ADDENDUM NO. 2

June 7, 2021

**HANOVER COMMUNITY SCHOOL CORPORATION - NEW RESOURCE
CENTER AND RELATED WORK
Cedar Lake, IN 46303**

This Addendum consists of page ADD 2-1 through ADD 2-2 and attached Addendum No. 2 from Gibraltar Design dated June 3, 2021 and consisting of 4 pages, Specification Section 07 42 64 Metal Panel Soffit, Specification Section 07 53 23 Roof Insulation and Membrane Roofing – EPDM, and 43 drawings.

© GIBRALTAR DESIGN SHEET
A-101

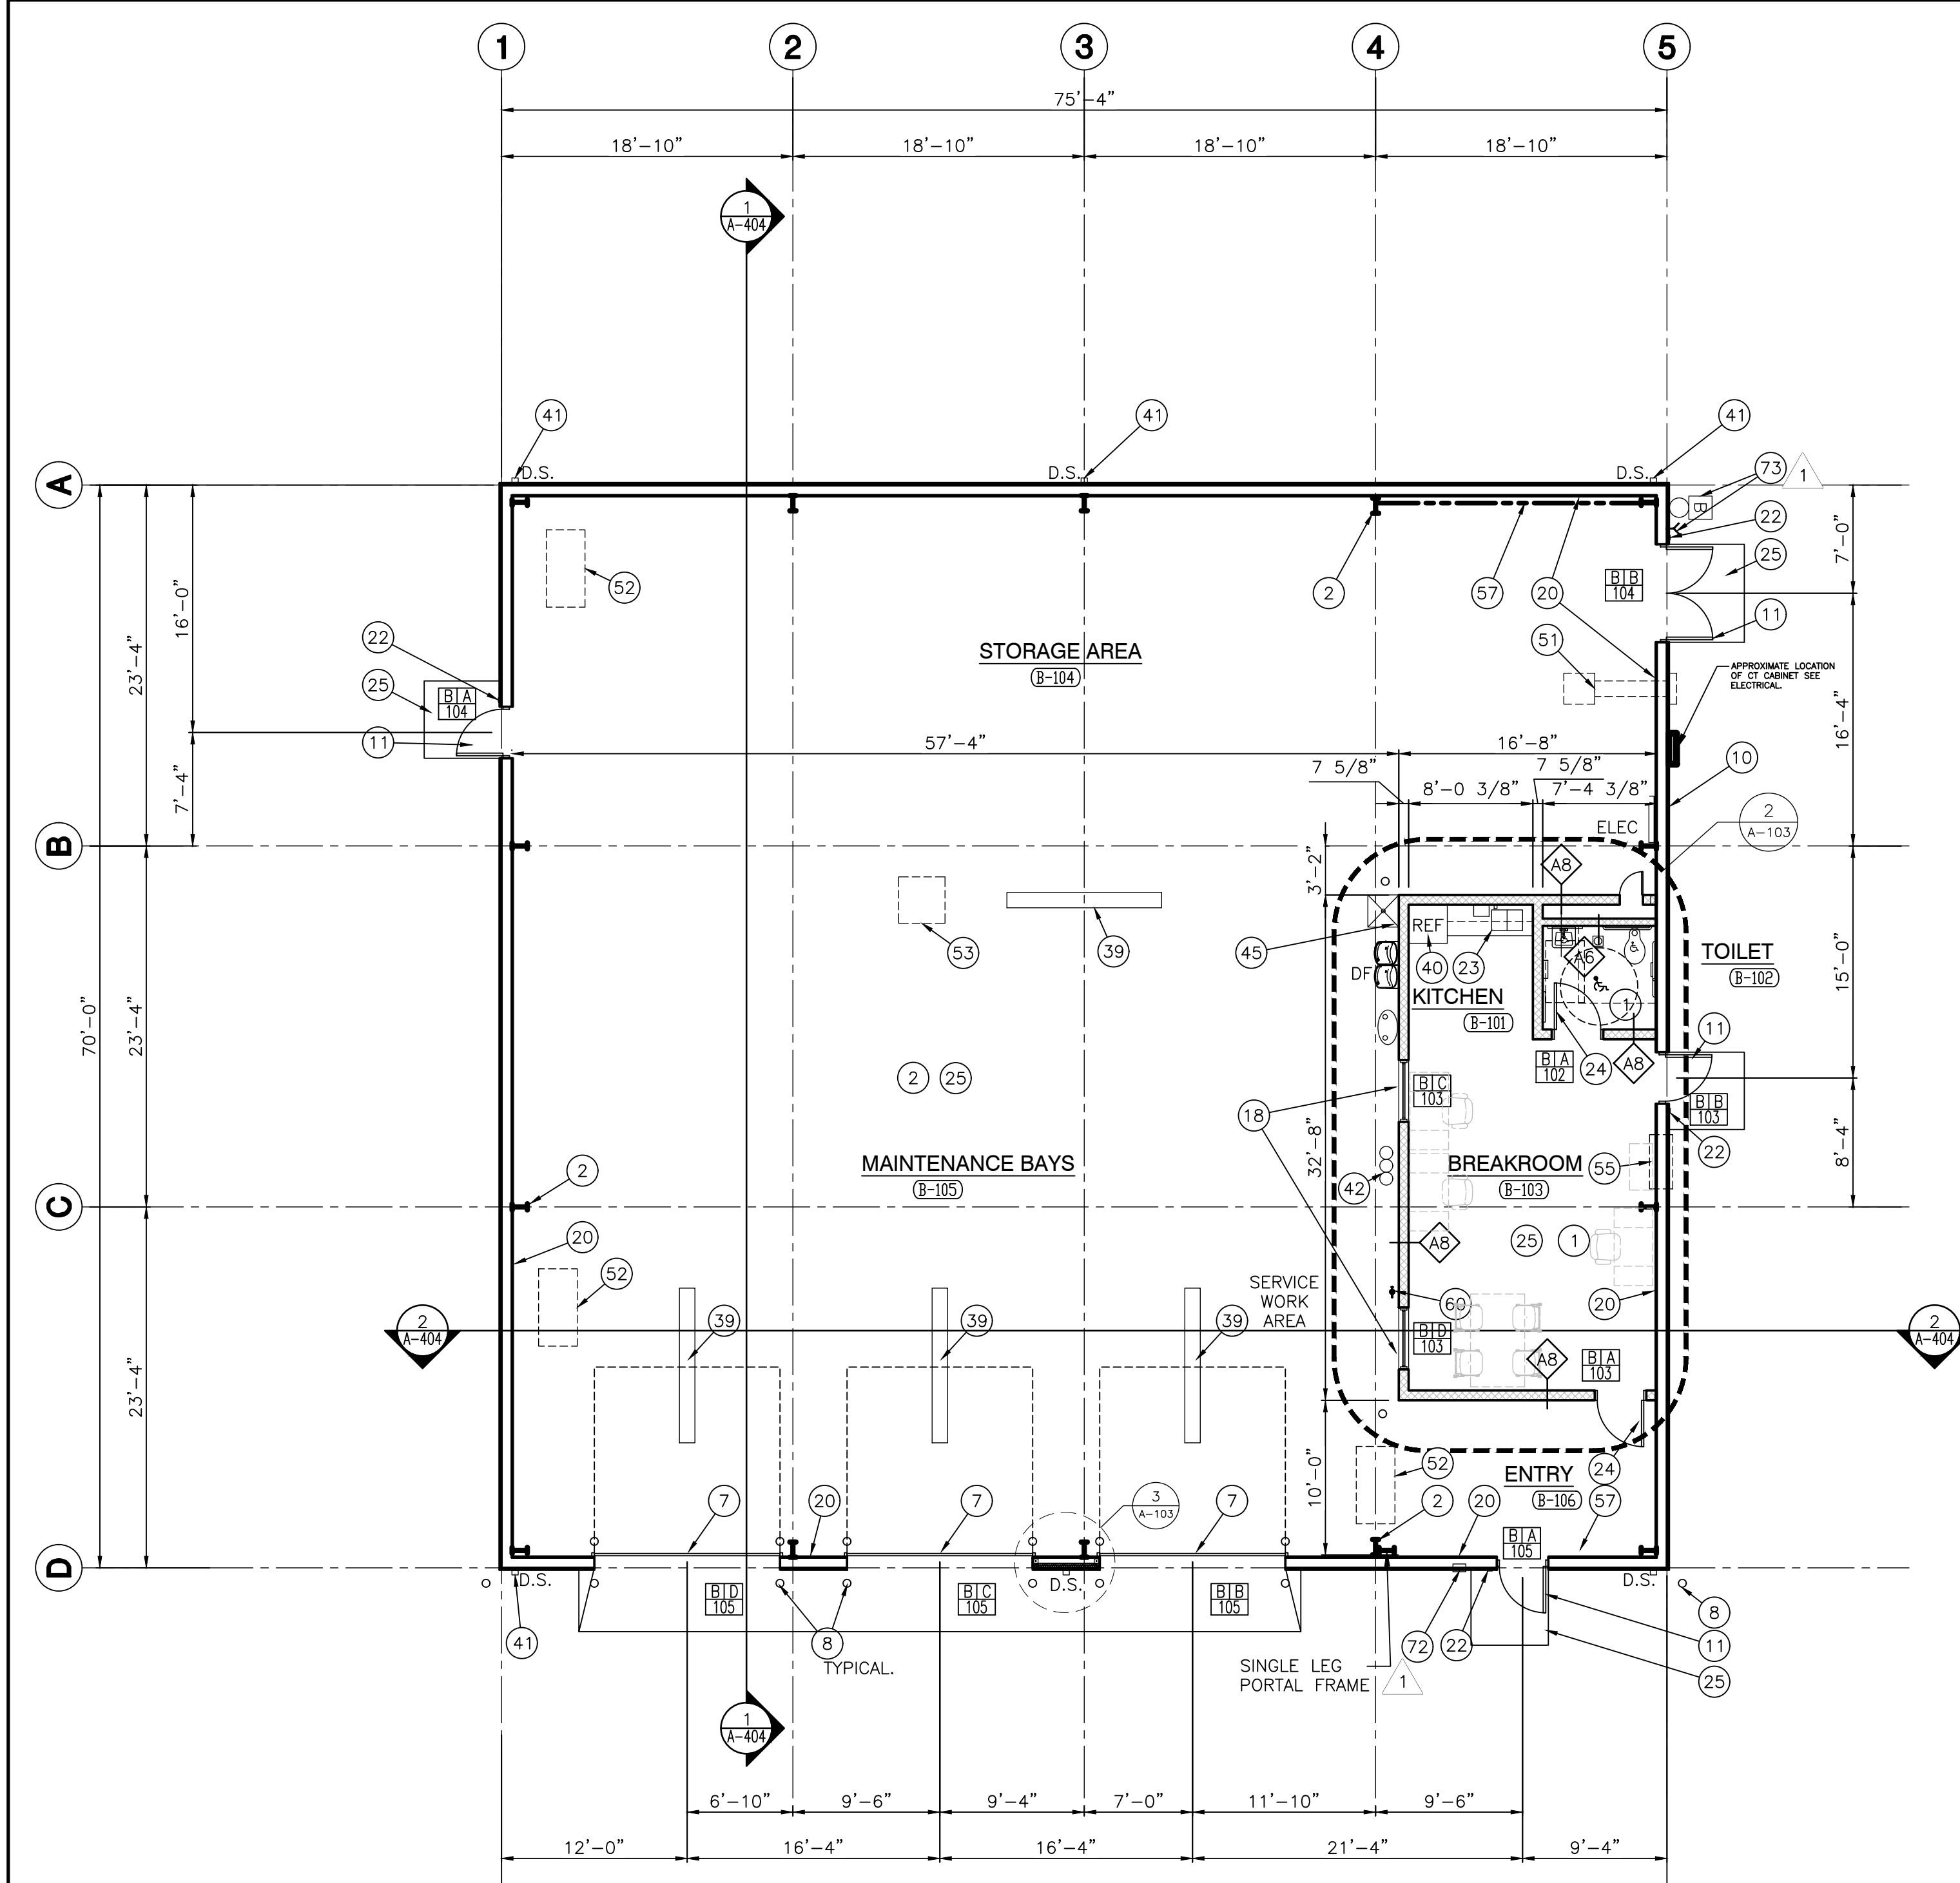
- A. Refer to Toilet Room C-104, Add Note 58 to point to the two metal lockers in the northwest corner of room.

DRAWING
ROOF PLANS

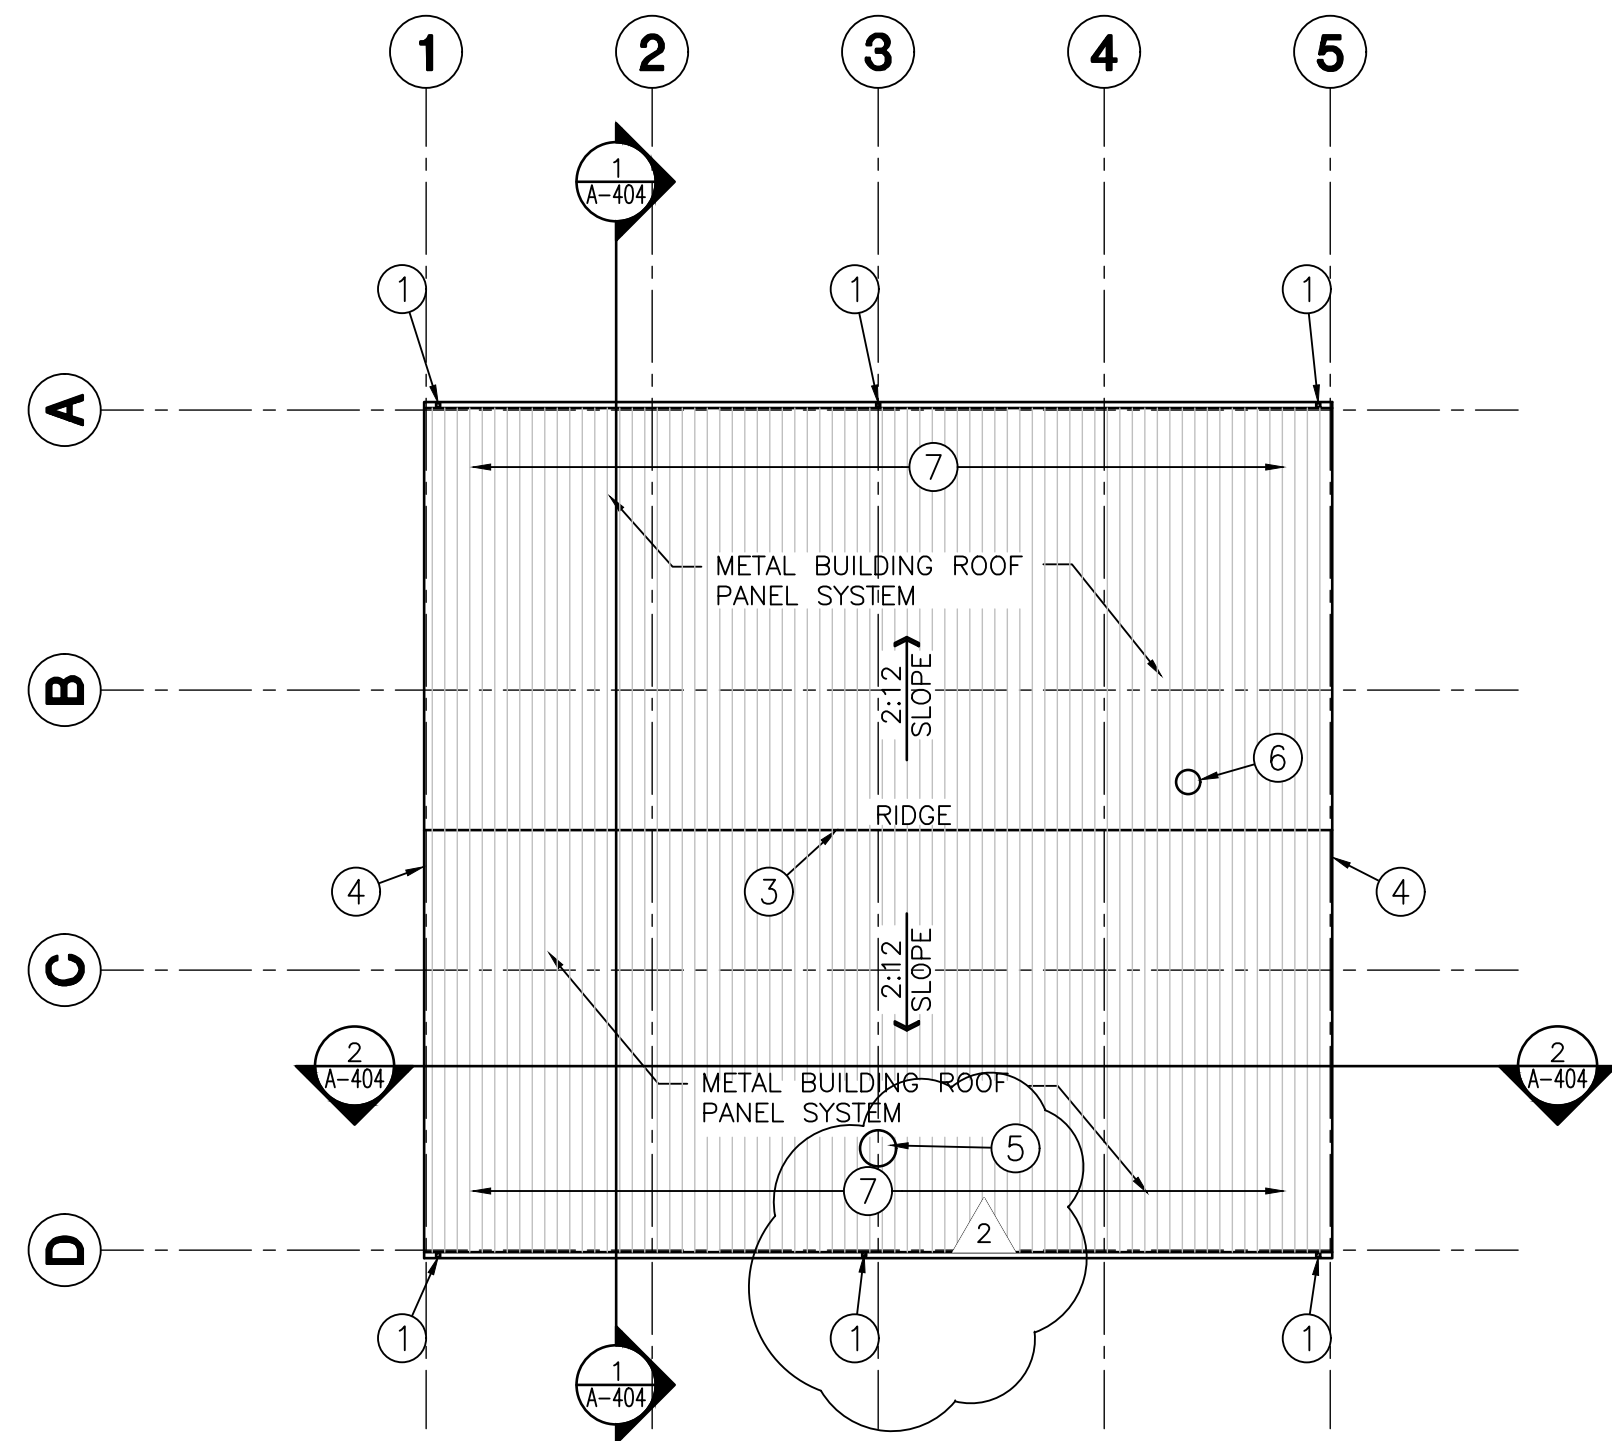
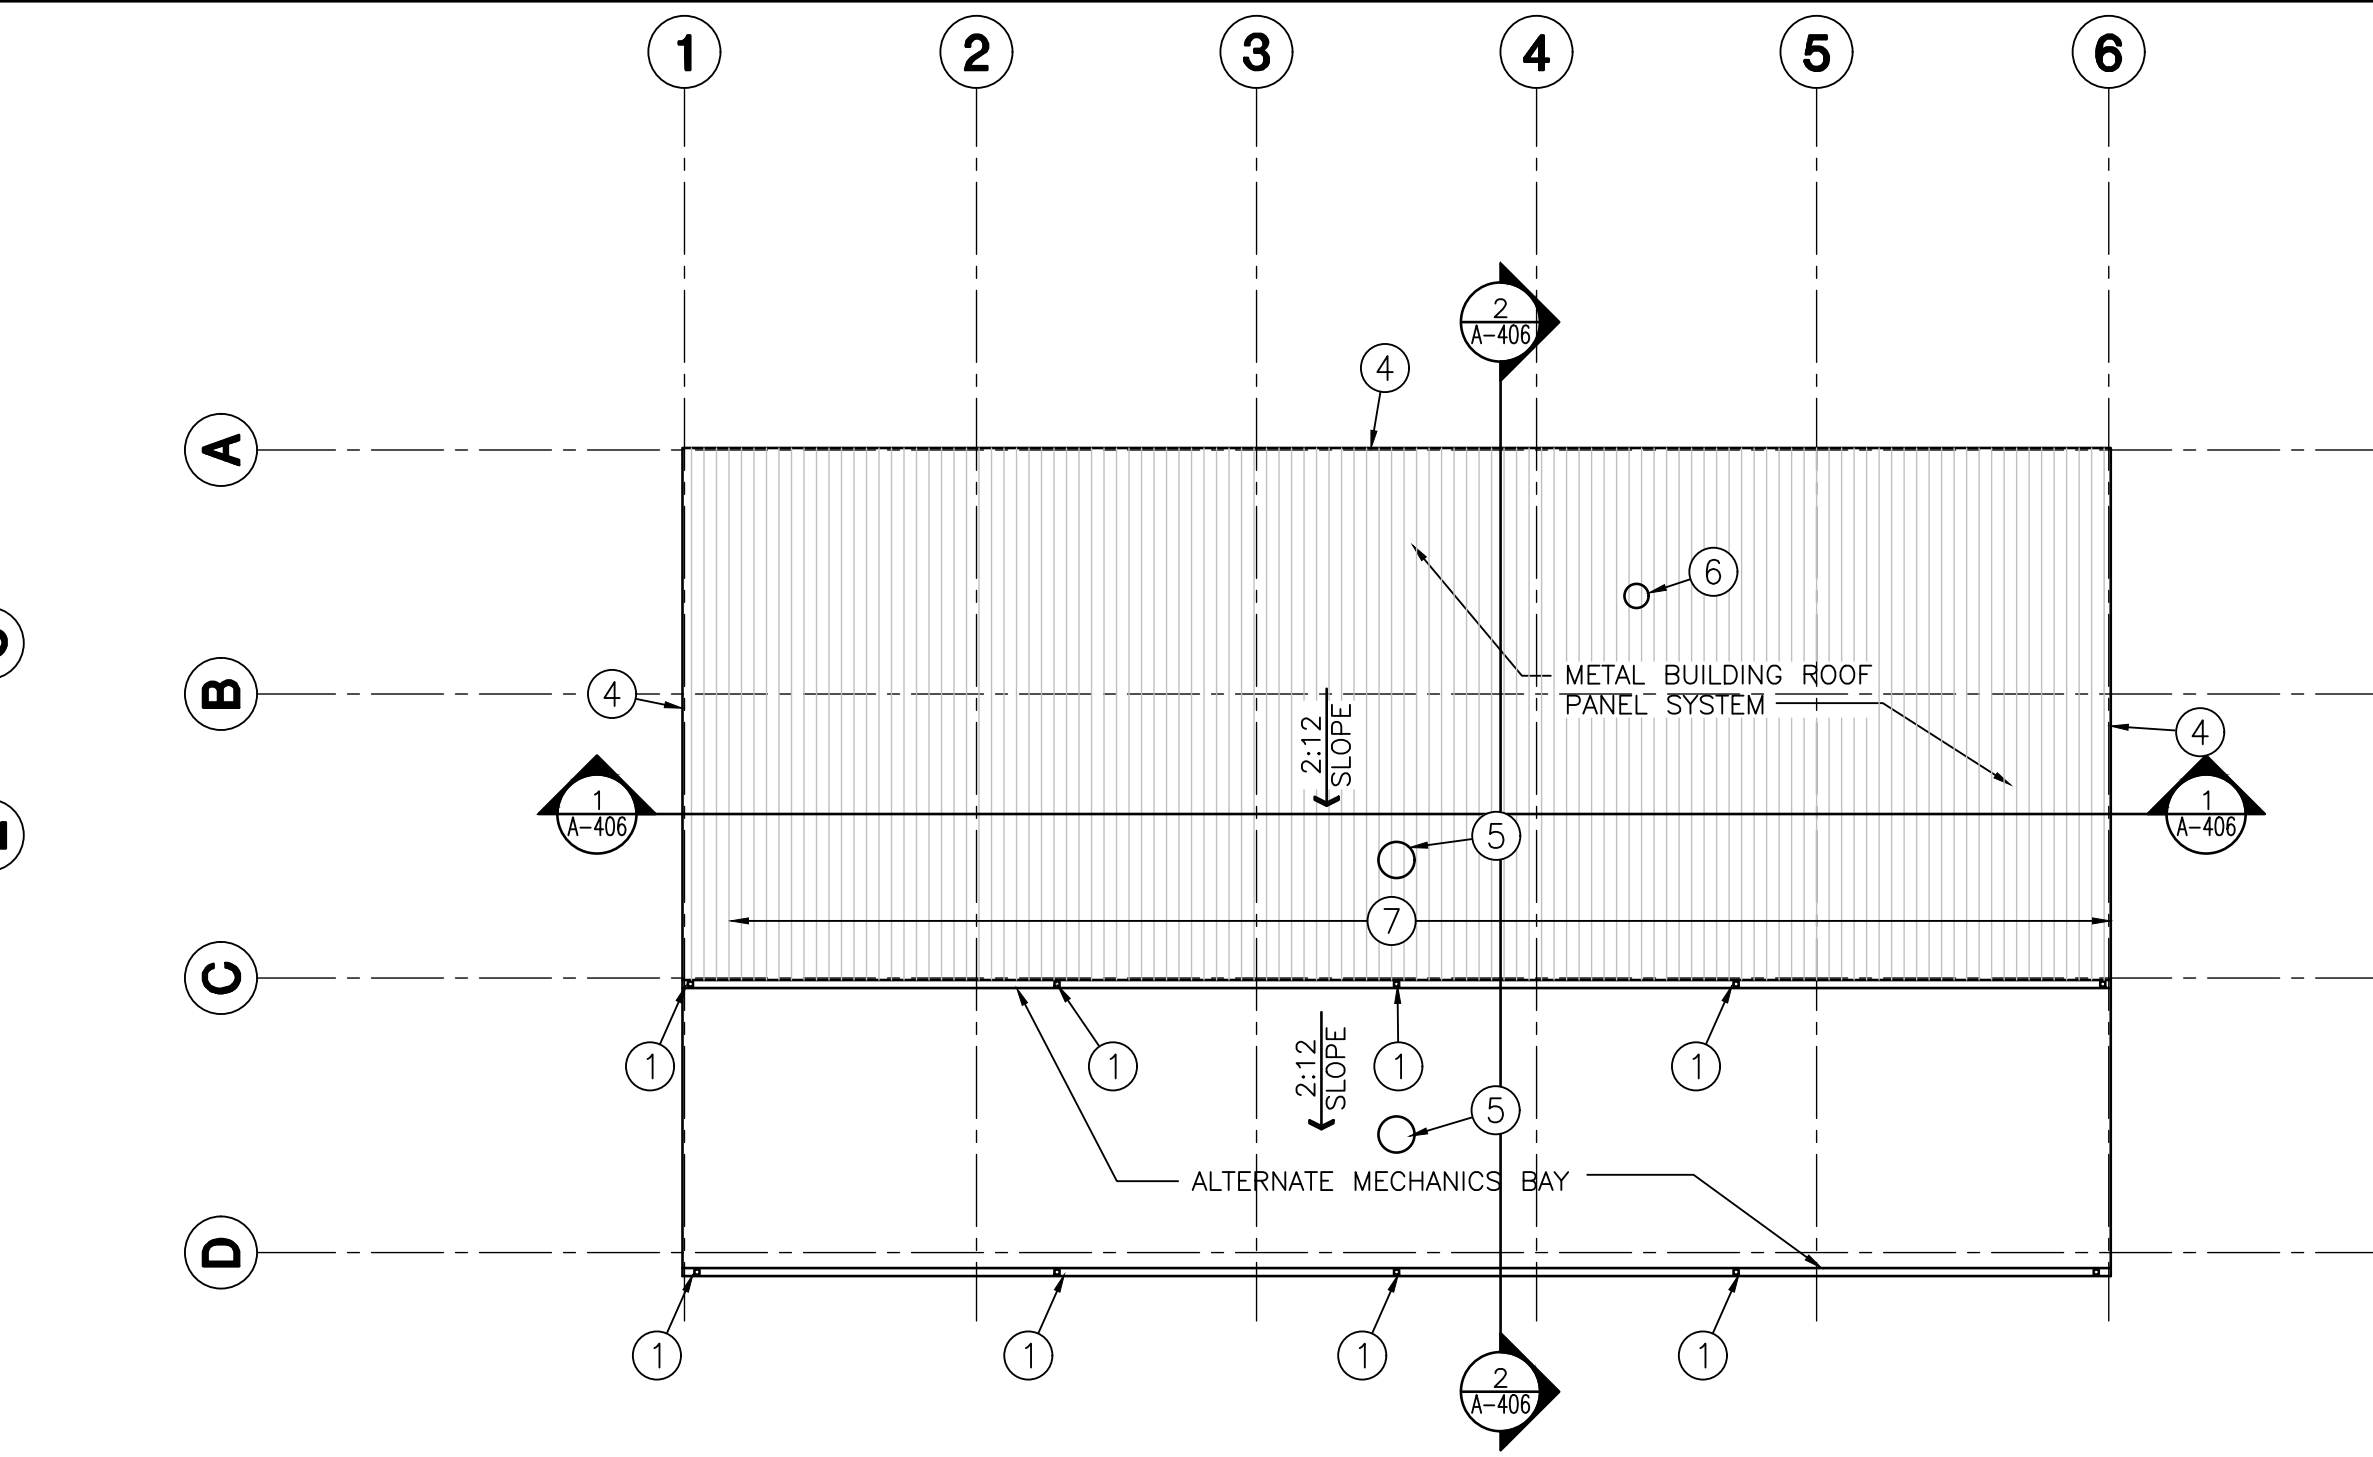
8. Sheet A-201

- A. Refer to revised Full Size Drawing Sheet included in this Addendum for revisions.
